Red = October additions Struck-out = October deletions Green = January additions Struck-out = January deletions

Numbers after additions & deletions refer to Comments in August Matrix [1 - 222] ;  
[E] refers to EPC Comments; [S] refers to Staff Recommendation

### C. Traffic Movement, Access Management, and Roadway Design

Figure C-3: Example 6-Lane Typical Sections with CURBSIDE Bus/BRT Lanes for COORS BOULEVARD/COORS BYPASS (NM45)

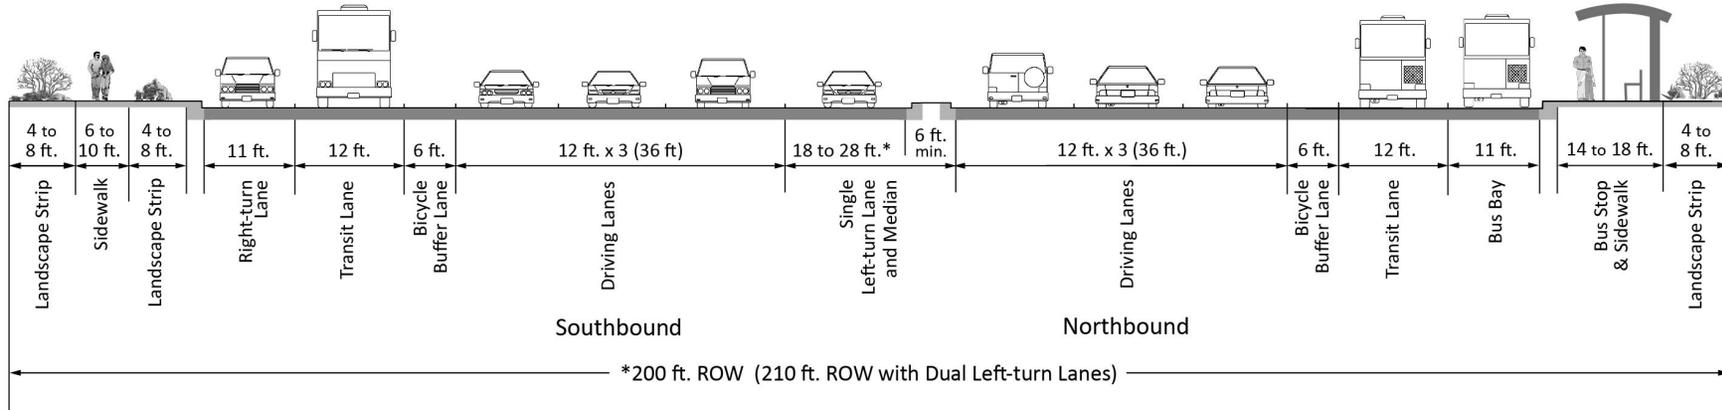
B. Section at Intersection with curbside BRT Station (see 4.2) [37]

**Figure C-4:** Example 6-Lane Typical Sections with MEDIAN BRT Lanes for COORS BOULEVARD/COORS BYPASS (NM45)

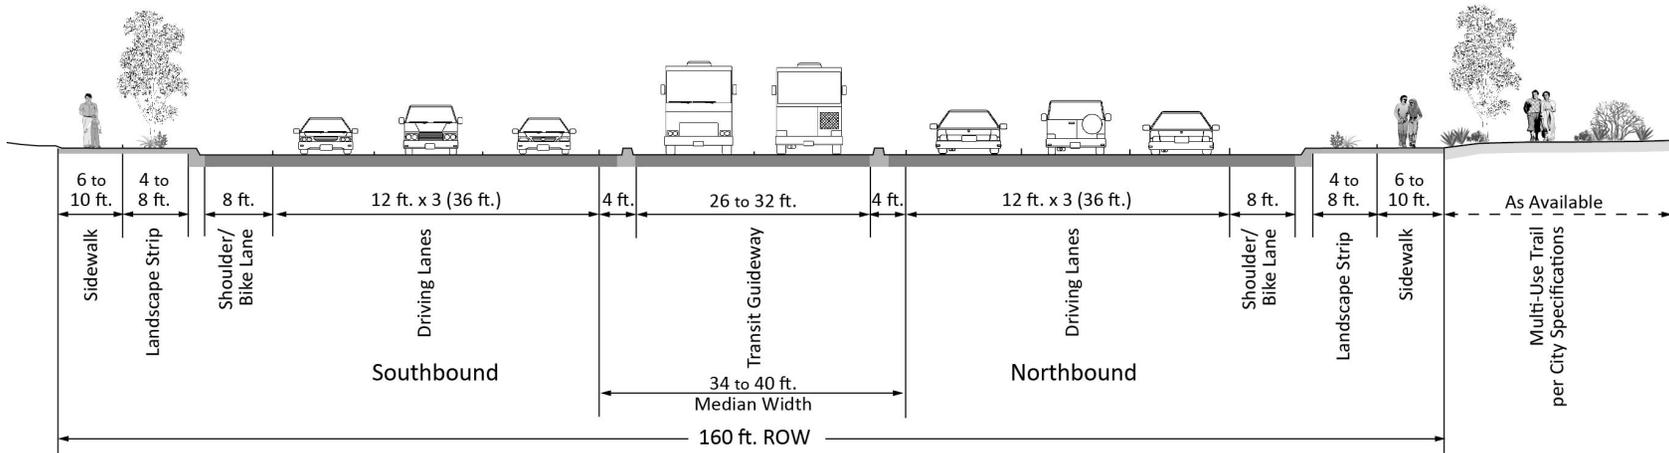
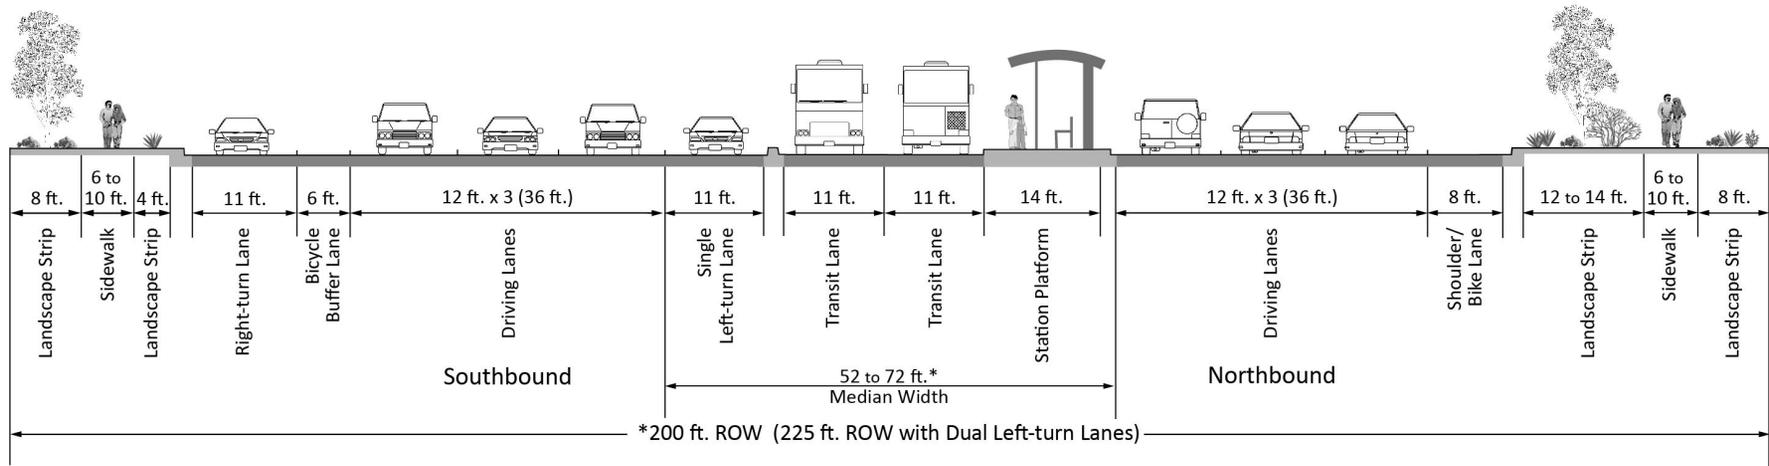
#### B. Section at Intersection with Median BRT Station (see 4.2) [37]

**Figure C-5: Example 4-Lane Typical Section for COORS BOULEVARD from Coors Bypass to Alameda Boulevard (NM448)**

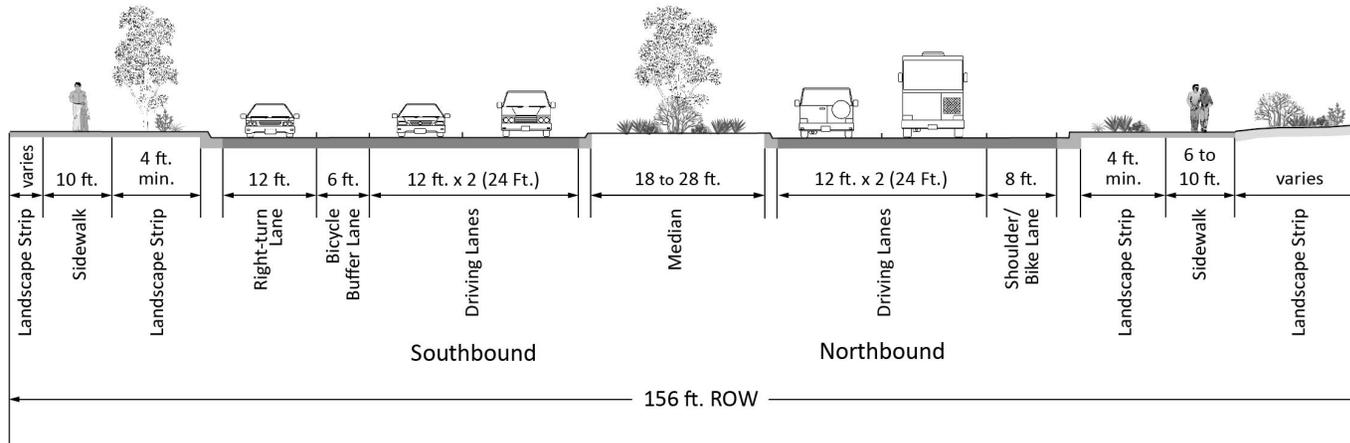
**Notes:** 1) Minimum 10 foot sidewalks are required in Major Activity Centers and Community Activity Centers as defined in the Albuquerque/Bernalillo County Comprehensive Plan. 2) Transit vehicles also use southbound driving lanes. [31]

Figure C-14: St. Josephs Drive to Dellyne Avenue / Learning Road

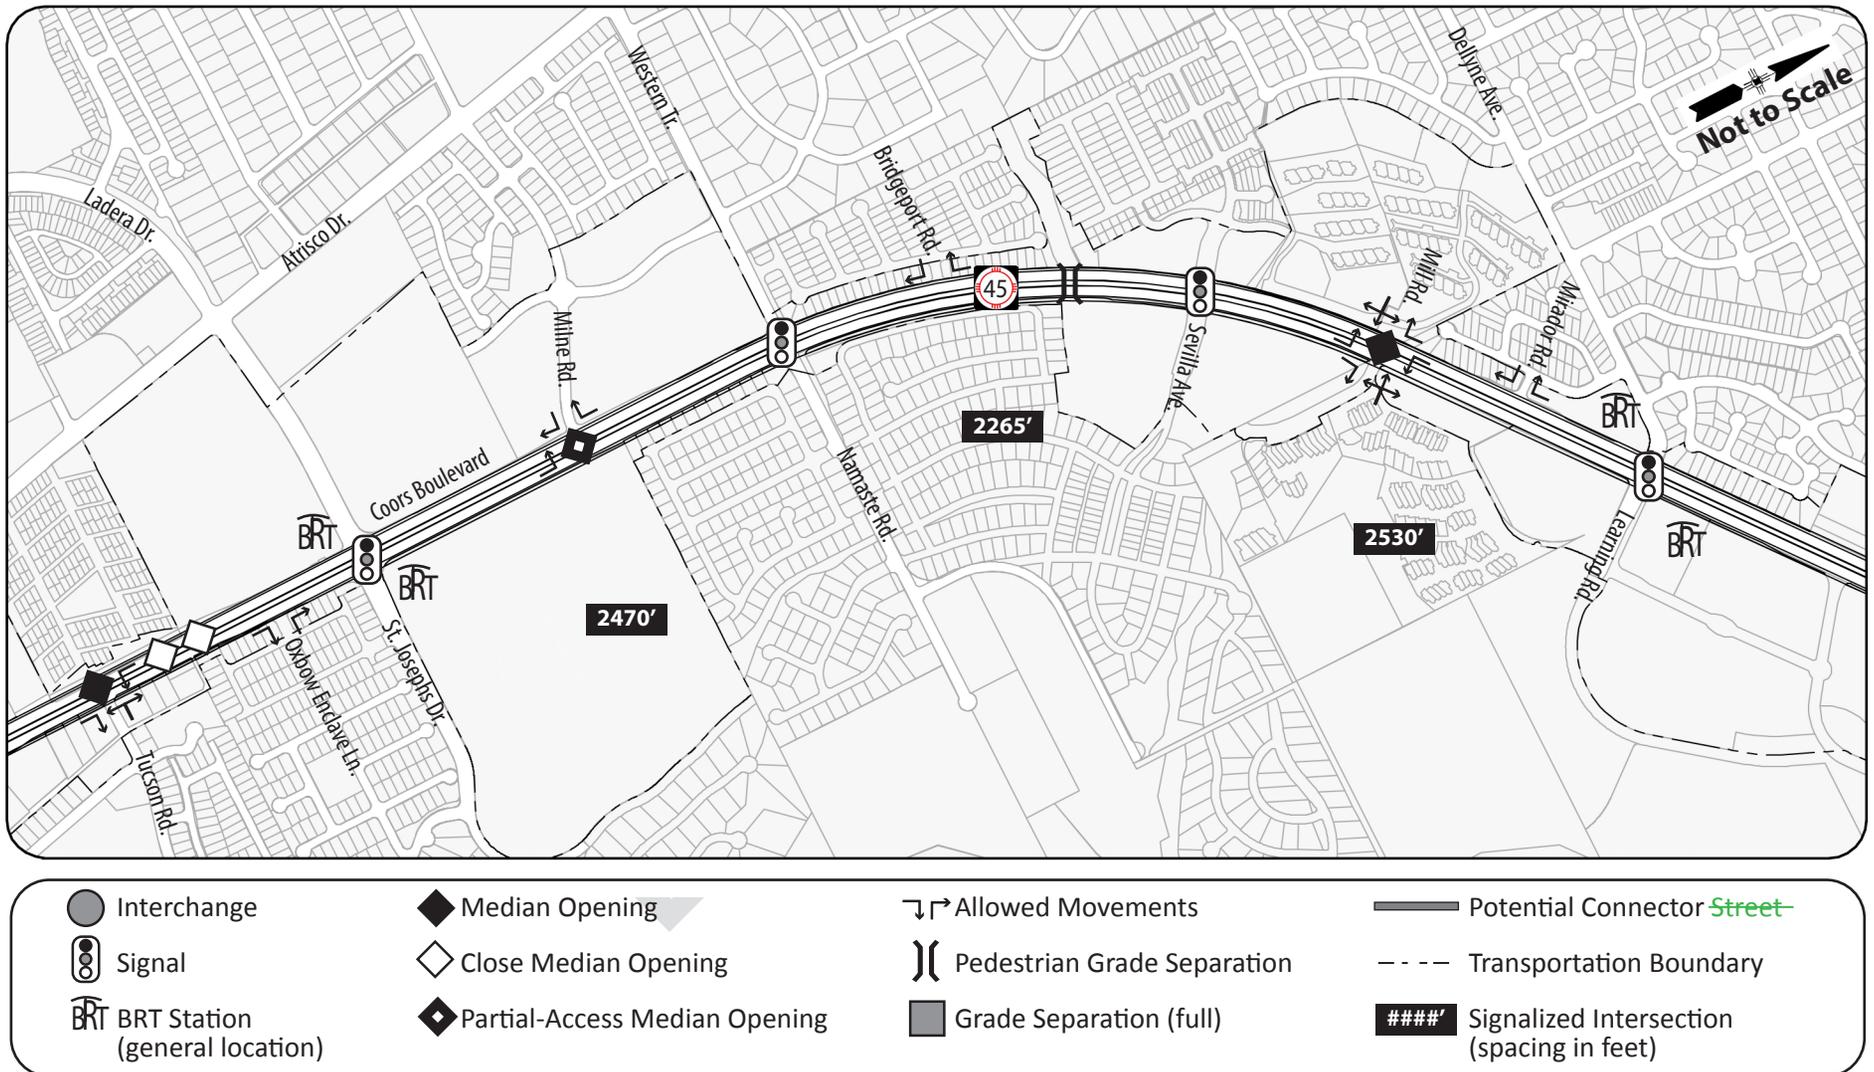
- a. ~~West of Coors Blvd., Costa Maresme Drive to Dellyne Avenue [See Figure C-14 and Table C-4]~~
  - a. East of Coors Blvd., Winter Haven Road to Bosque Plaza Lane [See Figure C-15 and Table C-5]. **This connector would serve pedestrians and cyclists rather than motorized vehicles, pending an assessment and resolution of cut-through traffic issues on Winter Haven to and from Montano Rd.**

Item	Policy	Existing Condition (2012) / Potential Change
6. Connector Streets	Develop additional local streets and/or street connections parallel to Coors Boulevard to provide alternative access to adjacent development	<del>Construct a connector street from Costa Maresme Drive to Dellyne Avenue.</del> No changes recommended for this segment.

**Figure C-15:** Dellyne Avenue / Learning Road to La Orilla Road

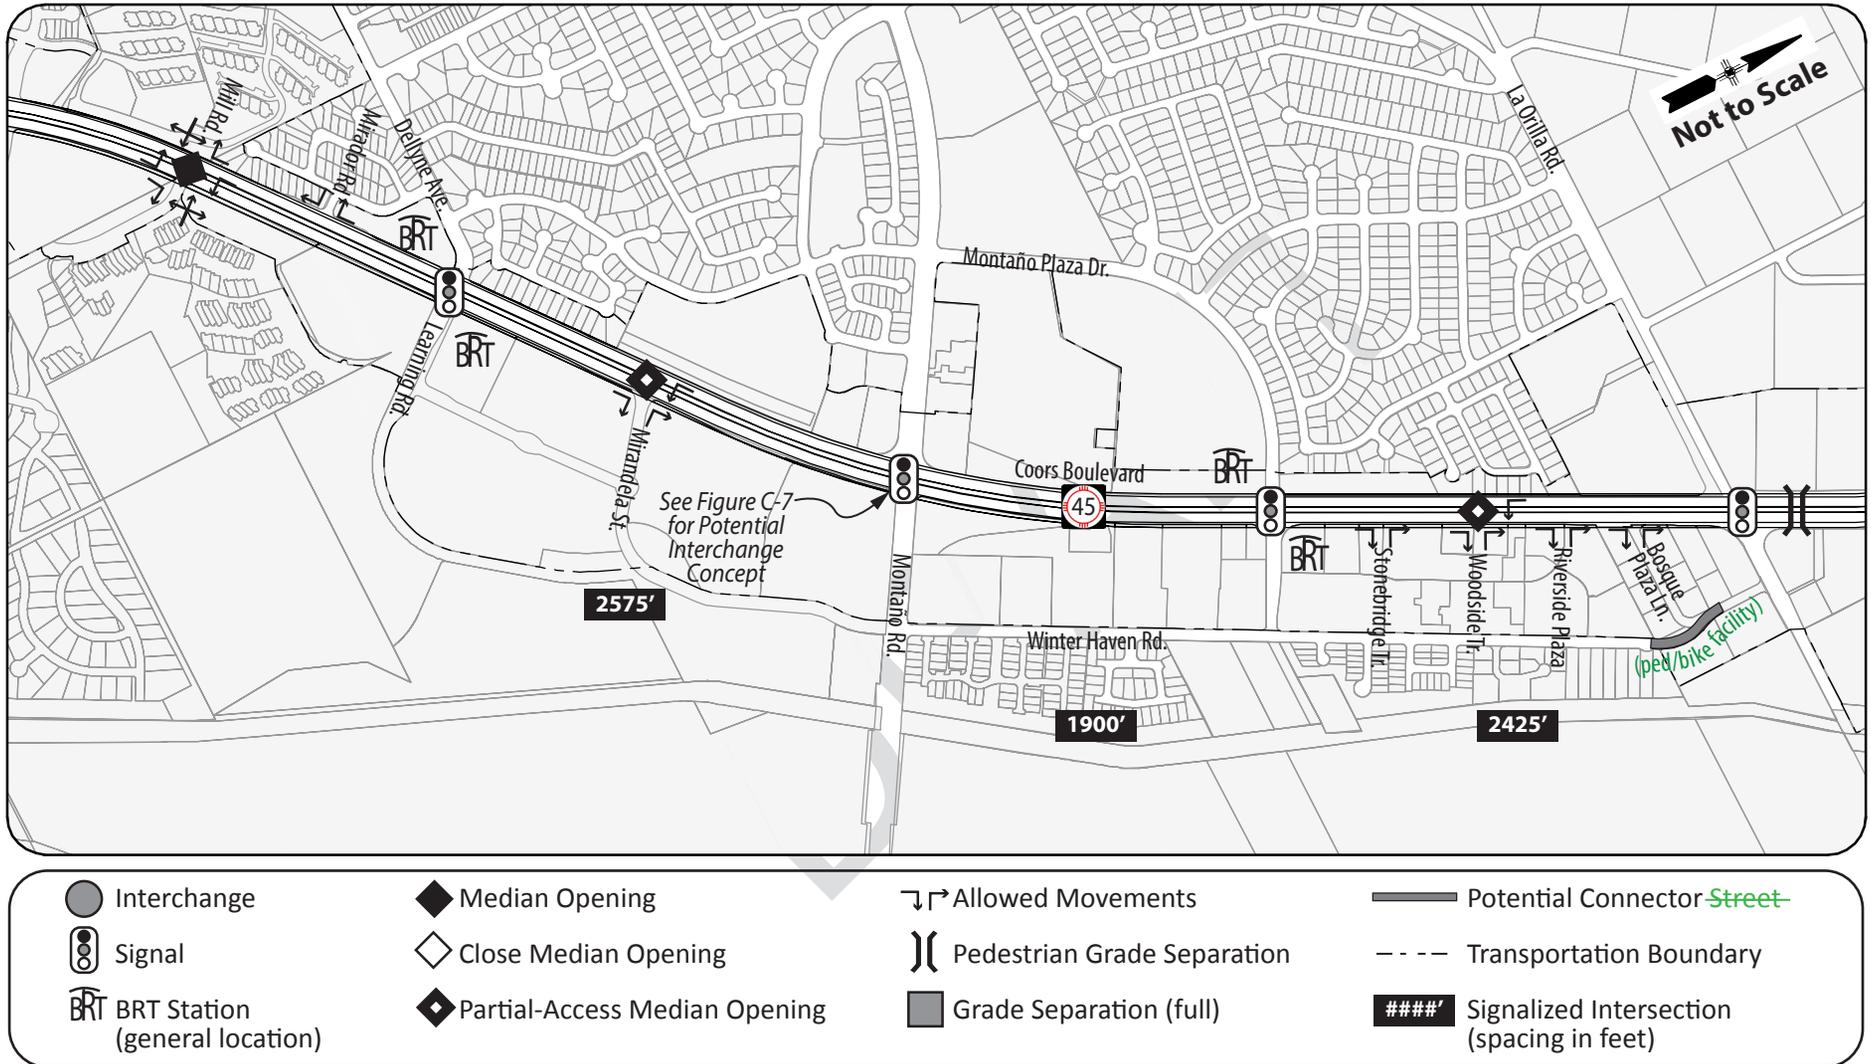
6. Connector Streets	Develop additional local streets and/or street connections parallel to Coors Boulevard to provide alternative access to adjacent development.	Construct a <b>pedestrian and bike</b> connector <del>street</del> from Winter Haven Road to Bosque Plaza Lane.
